TPA/40955/C-VCAT Directed

Attachment 2: 170-174 Highbury Road, Mount Waverley

PROPOSED MIXED USE DEVELOPMENT AT 170-174 HIGHBURY ROAD, MOUNT WAVERLEY

SECONDARY - CONSENT.2 APPLICATION

DATE: 15.07.20	SCALE: 1:100	NORTH
DRAWN: M.S./M.I./S.L	CHECKED: G.P	
JOB No: 20-08		
DWG No: TP02		REVISION N

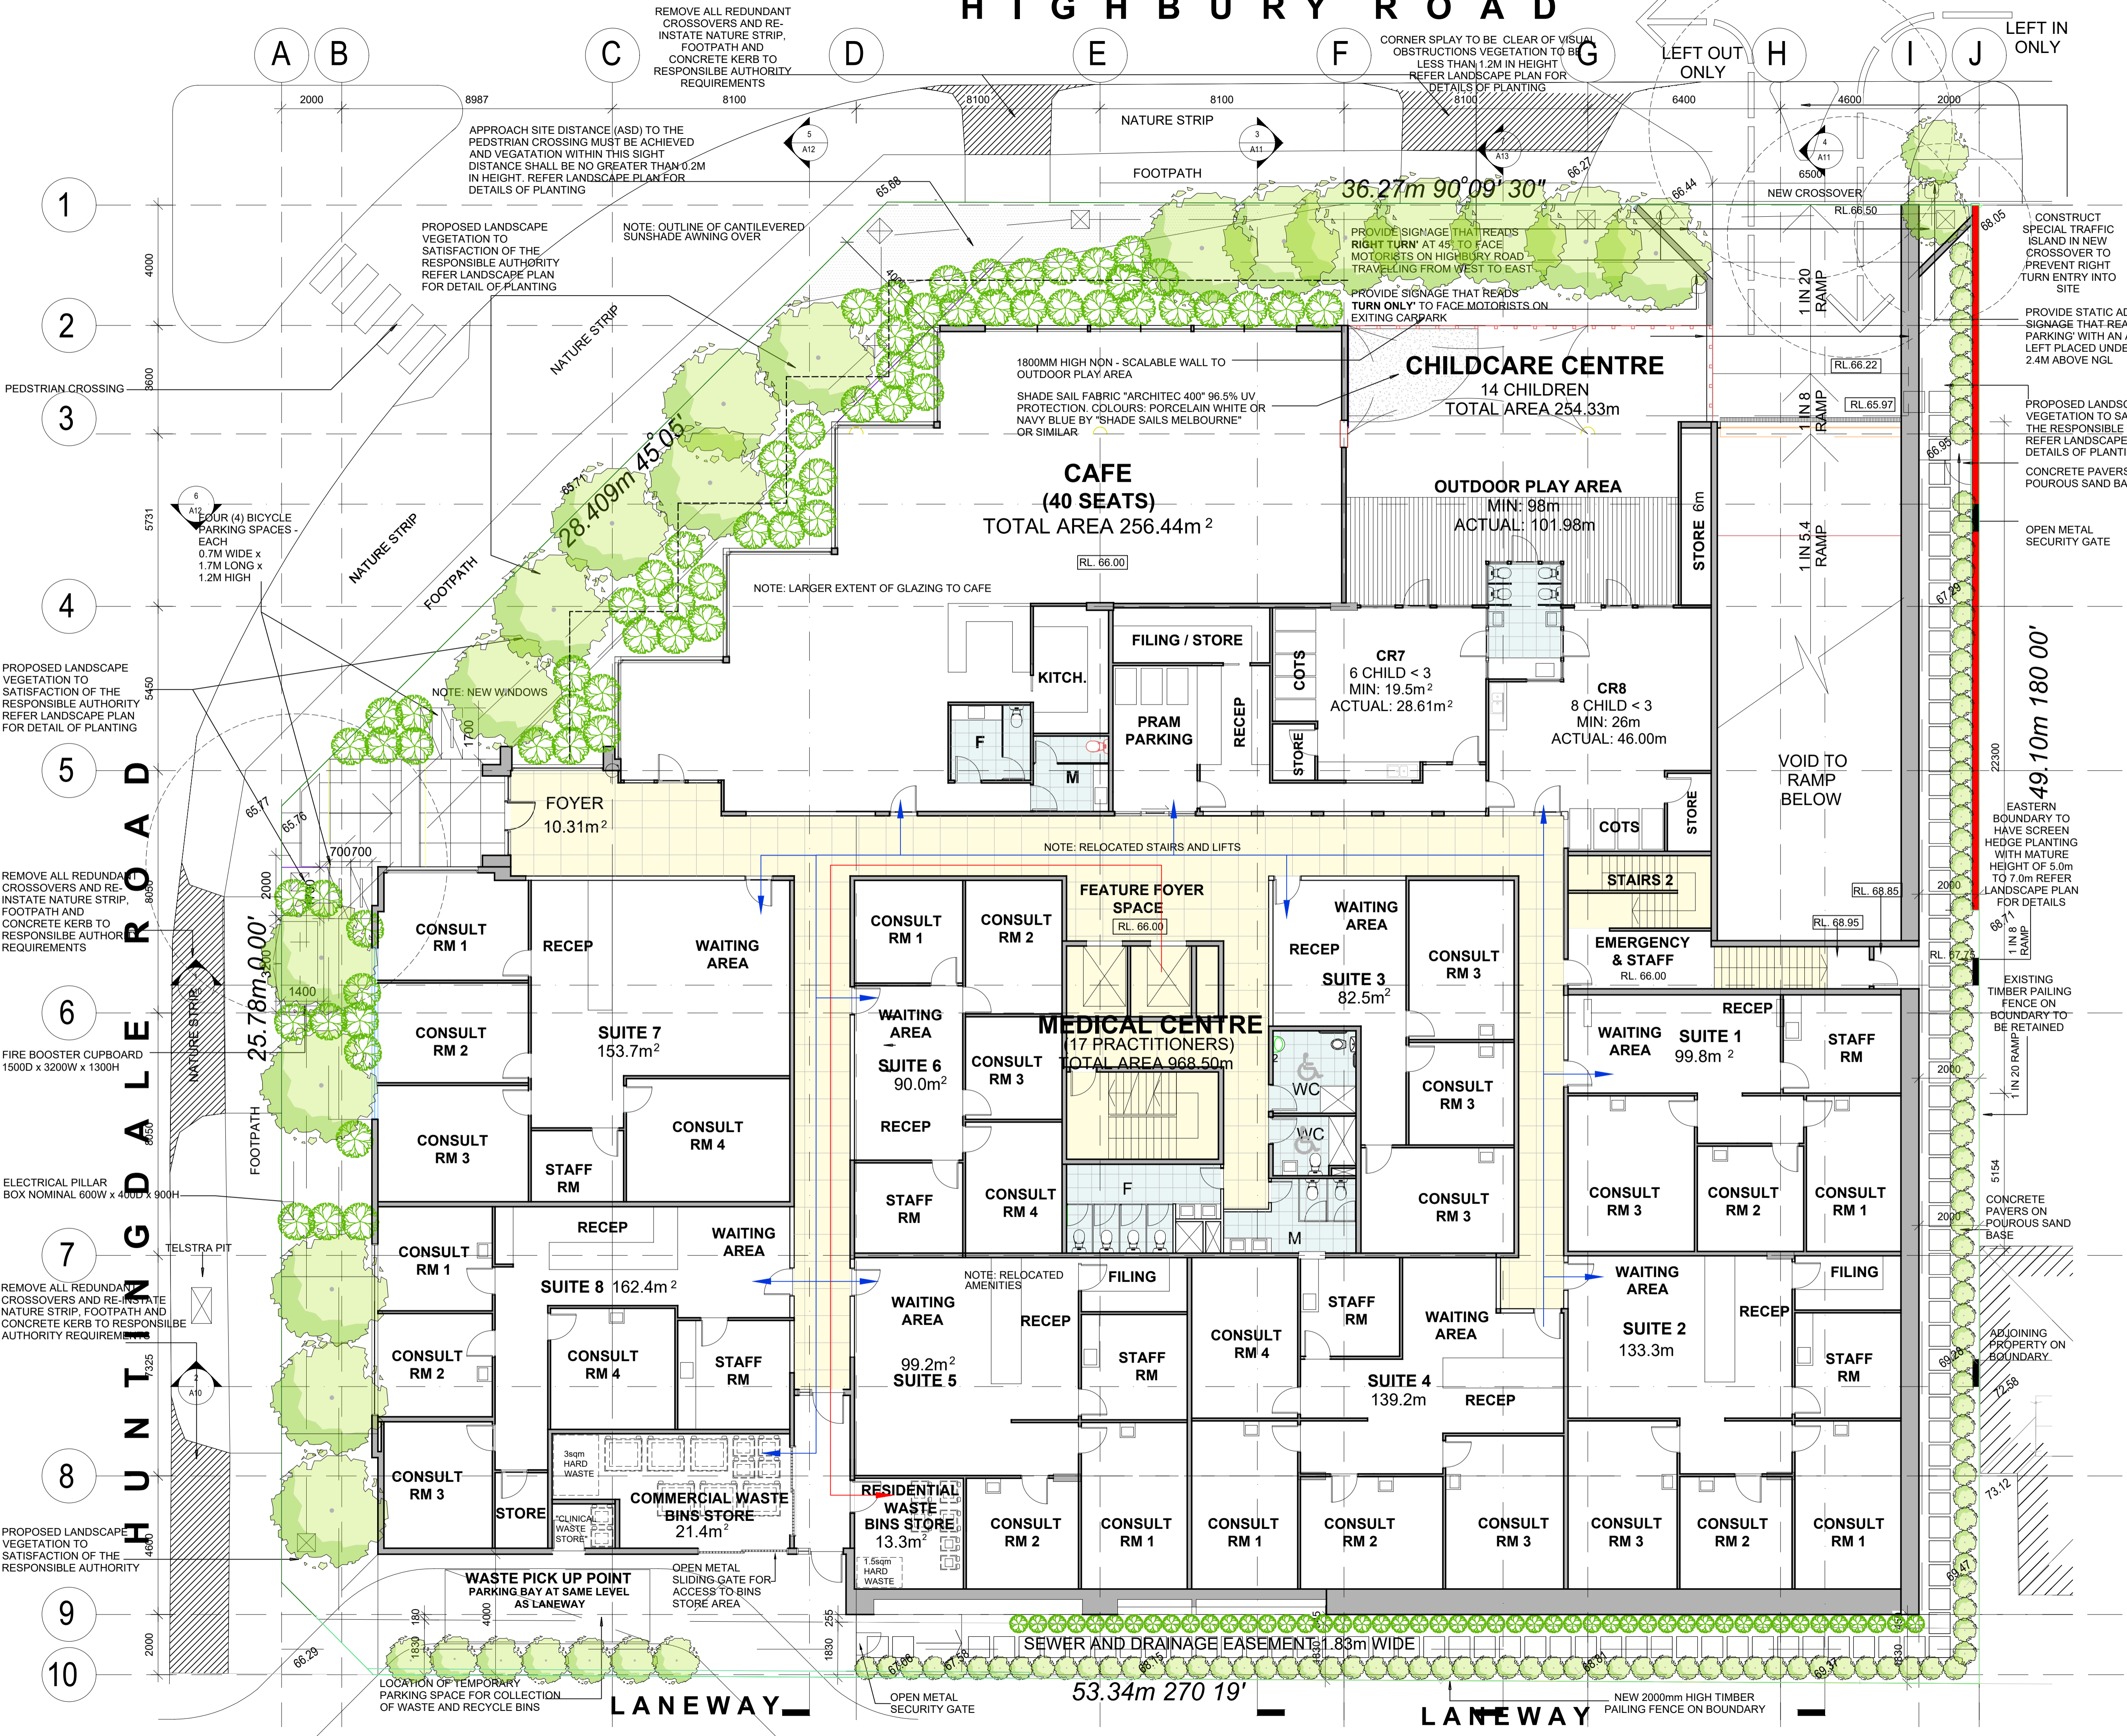
- (a) The deletion of the following expressions on drawing no. TP02:
 - '3 PRACT', being located under the expression 'SUITE 1'.
 - '3 PRACTITIONERS', being located under the expression 'SUITE 2'.

- '4 PRACTITIONERS', being located under the expression 'SUITE 3'.

- '3 PRACTITIONER', being located under the expression 'SUITE 4'.
 - '3 PRACTITIONER', being located under the expression 'SUITE 5'.
 - '3 PRACTITIONERS', being located under the expression 'SUITE 6'.

- '3 PRACTITIONERS', being located under the expression 'SUITE 7'.
- (b) The entry to dwelling 10 from the foyer area and a wall between bedroom 1 and the adjoining dwelling 1.
